**PEER 24 - Performance Assessment Reviews (1990 to 1992)**

1991 PERFORMANCE ASSESSMENT REPORT  
INTERA REVIEW

Review of the  
1991 WIPP Assessment  
(SAND91-0893)

**Review of the 1991 WIPP Assessment  
(SAND91-0893)**

Figure 1: C'CDF for cuttings produced by simulation approach.

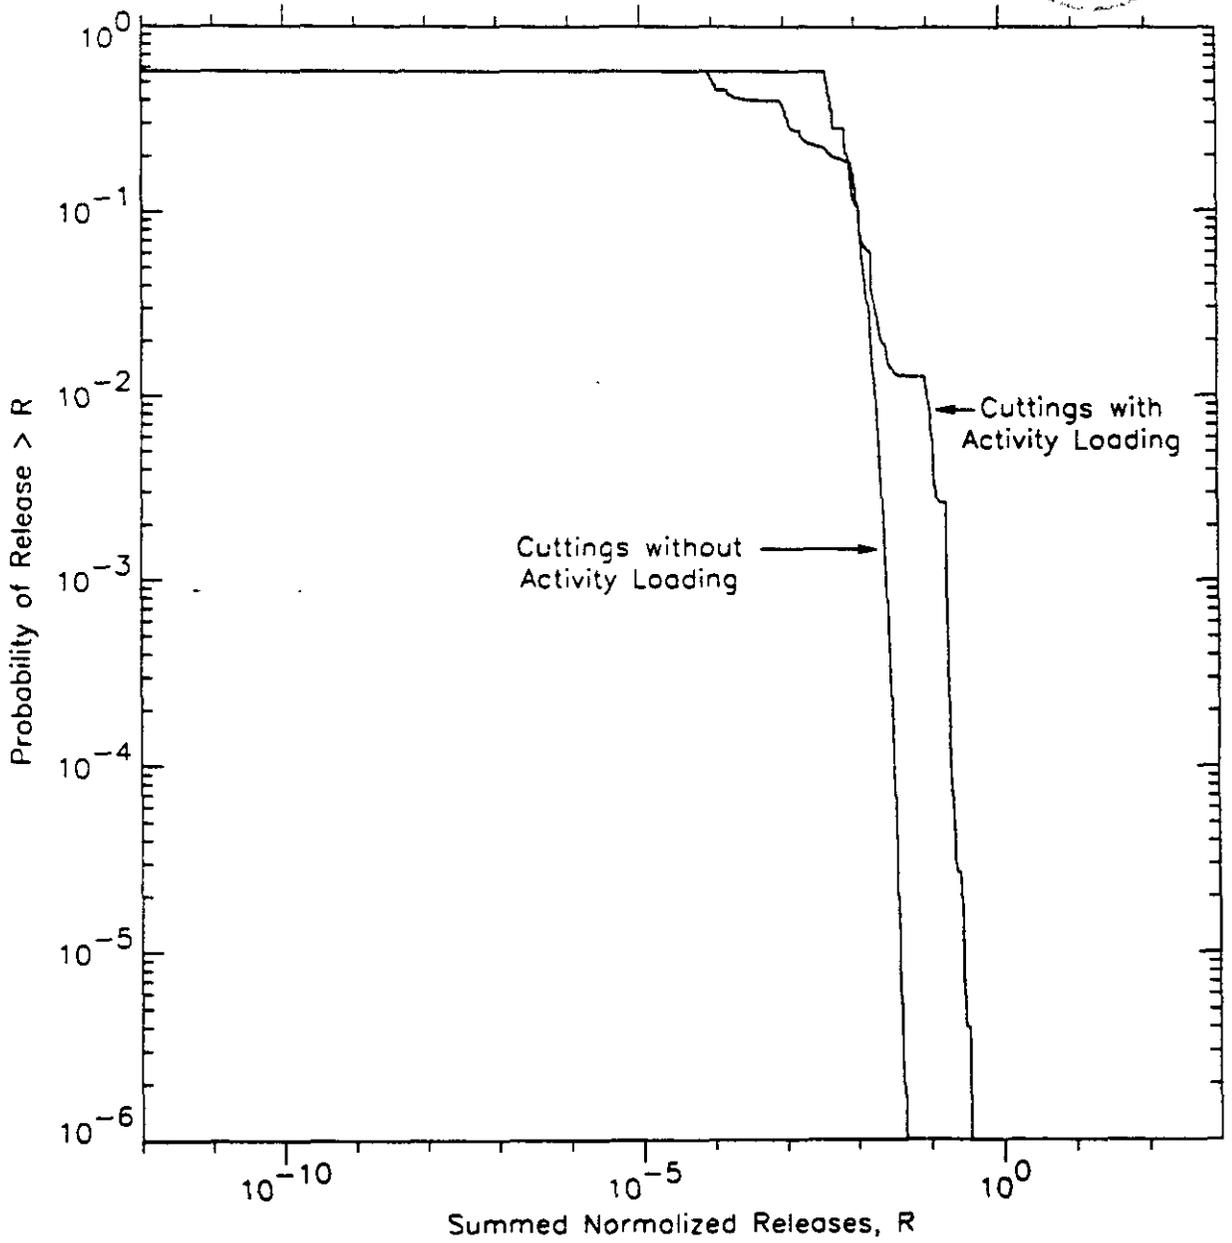
To illustrate the ease with which such an approach can be implemented, the results given in figure 3-4 for cuttings have been reproduced using a small C-program. For each future a sequence of intrusions is generated and the consequence cumulated. When activity loading is considered, the activity level of the penetrated waste is determined randomly according to the given probabilities.

Using this program, and binning the results, the CCDFs are generated. Those shown in figure 1 can be directly compared to figure 3-4 of the WIPP assessment Volume 2, and are found to be virtually identical.

Figure 2: CCDF for cuttings produced by simulation approach with continuously time-varying consequence.

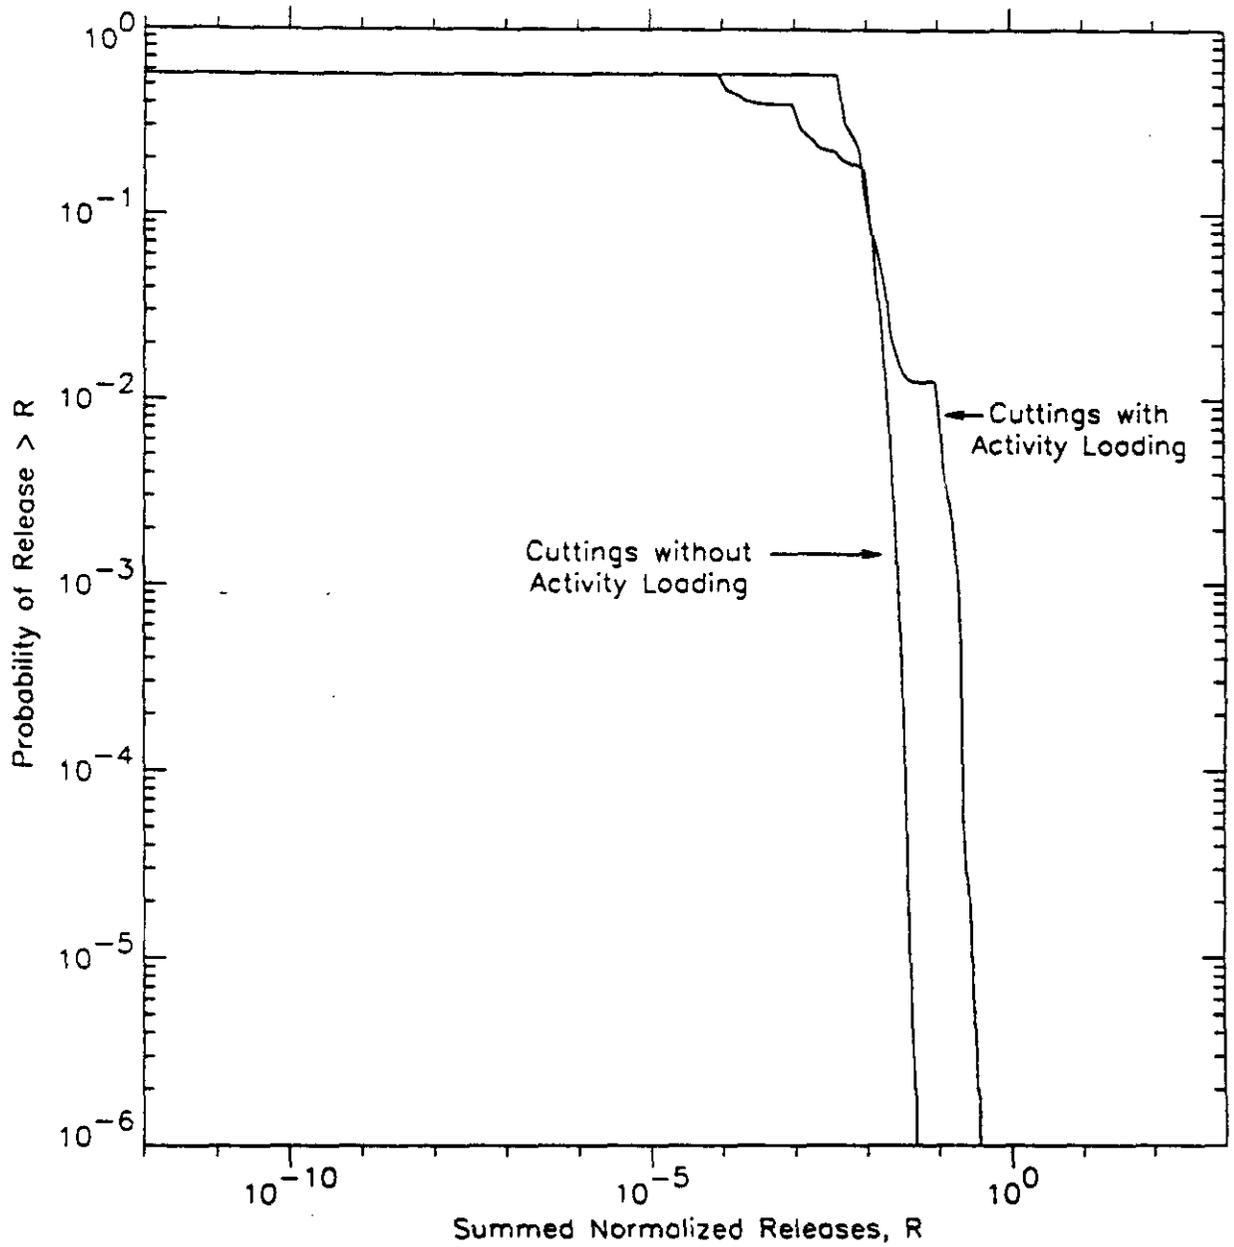
In addition to reproducing the results given, the simulator can be used to look at the possible effect of including time-dependence of the consequence more precisely. Obviously from the five time values given we cannot generate a full time history, and so we have interpolated (and extrapolated for early and late times) from these values. The tables in Appendix B indicate that the normalized releases are dominated by one or two nuclides and so tend to fall off exponentially. Therefore, a linear interpolation and extrapolation scheme has been used for the logarithm of the normalized release. The results with this scheme are shown in figure 2.

The major effect of this change is to smooth the CCDF somewhat. This is a direct result of the elimination of the discontinuities in consequence at 2000-year intervals.

Figure 1: Conditional risk curves (CCDFs), and position of the conditional mean in a full uncertainty analysis.

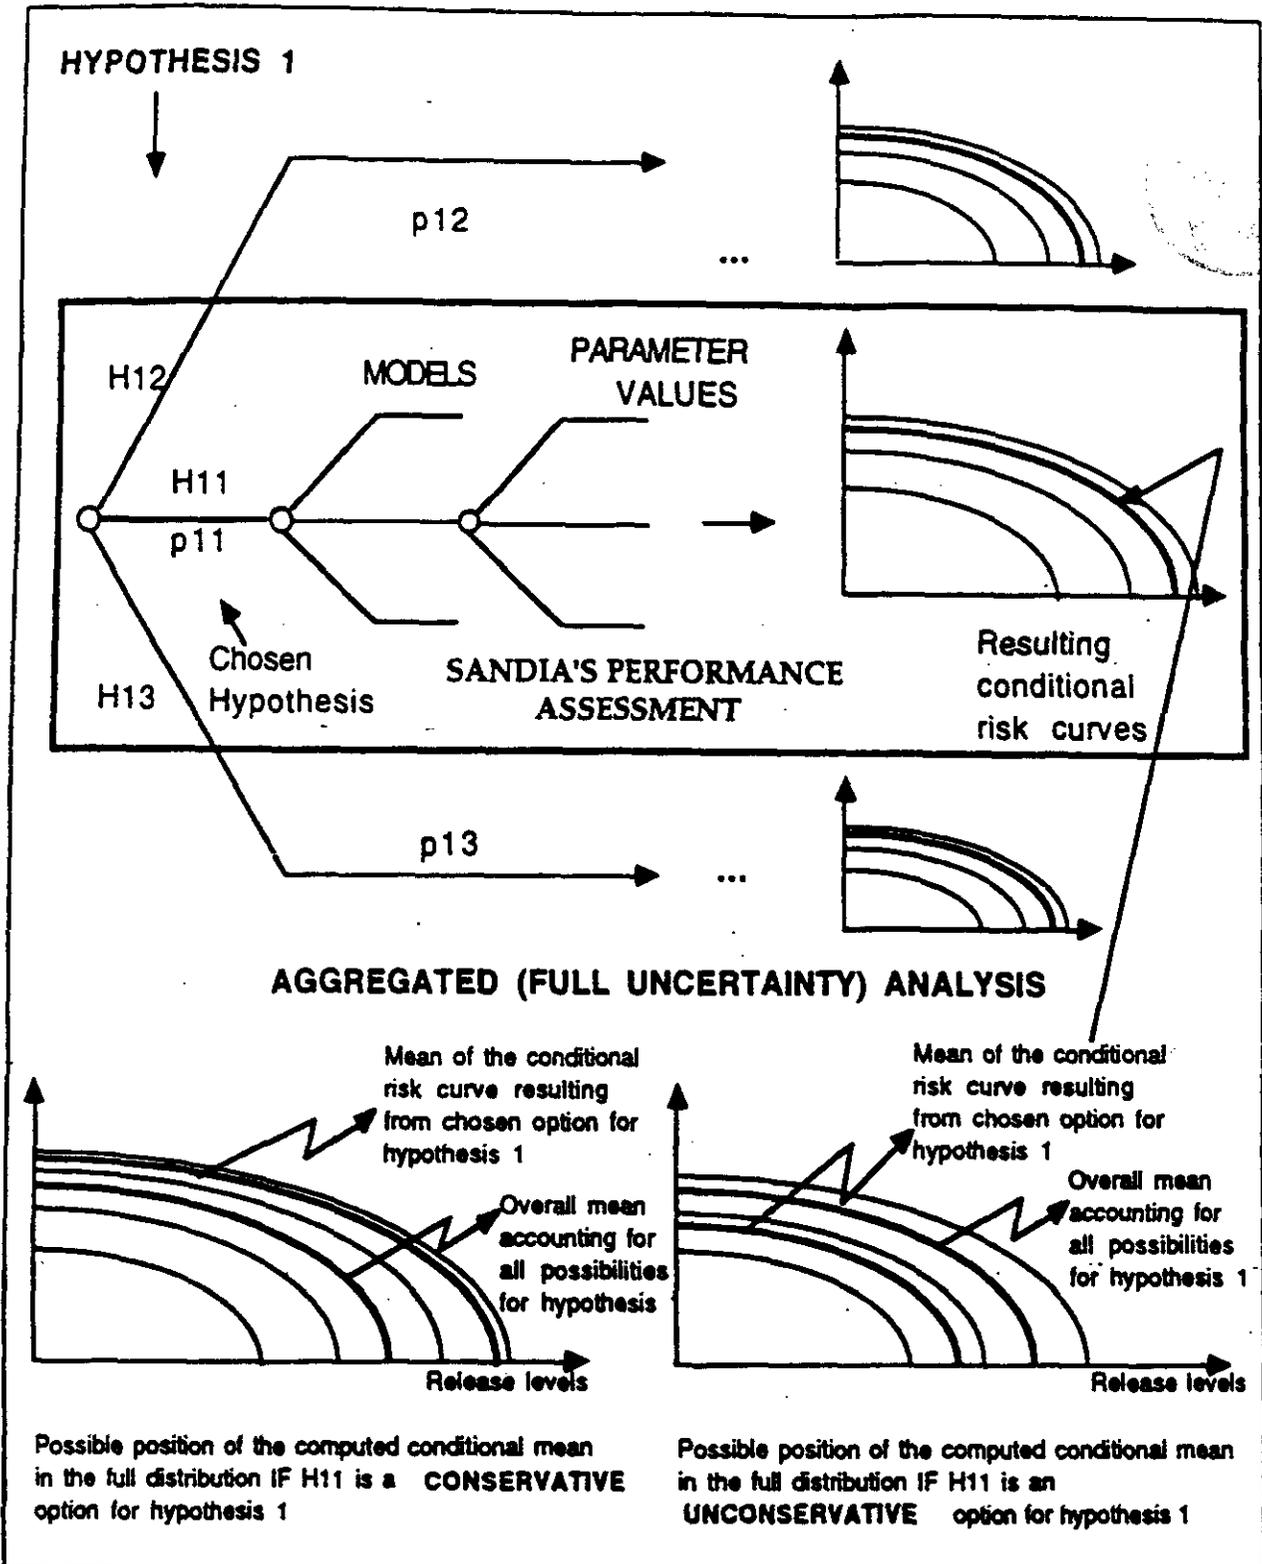
Therefore, I think that you want to know which one(s) of the real risk curves (that would result from a full uncertainty analysis as shown in Figure 1) are tangent to the compliance criteria curve, and possibly, what level of health safety do they represent. Two questions thus arise:

Therefore, you may want to examine the effects of hypotheses on the position of the current means in the family of CCDFs (fractiles) for release accounting for the EPA/DoE hypotheses as shown in Figure 1. Of course, you do not want to ask Sandia to redo the whole uncertainty analysis, but to give you a feeling for the final degree of conservatism of the release results after this accumulation of assumptions. This involves listing the main hypotheses (both from EPA and from the Sandia PA) and assessing (even coarsely) their cumulative effects on the position of conditional (current) means in

the CCDFs families. If it is the case that the EPA/DoE assumptions are generally conservative, it is likely that what are now mean curves in the current conditional performance analysis (Sandia's PA) would correspond to higher fractiles of distributions that would account probabilistically for all hypotheses (Figure 1, bottom left). If the set of assumptions turns out to be altogether unconservative, introducing alternative assumptions will tend to make the current means go down in the families of risk curves towards lower fractiles (Figure 1, bottom right).
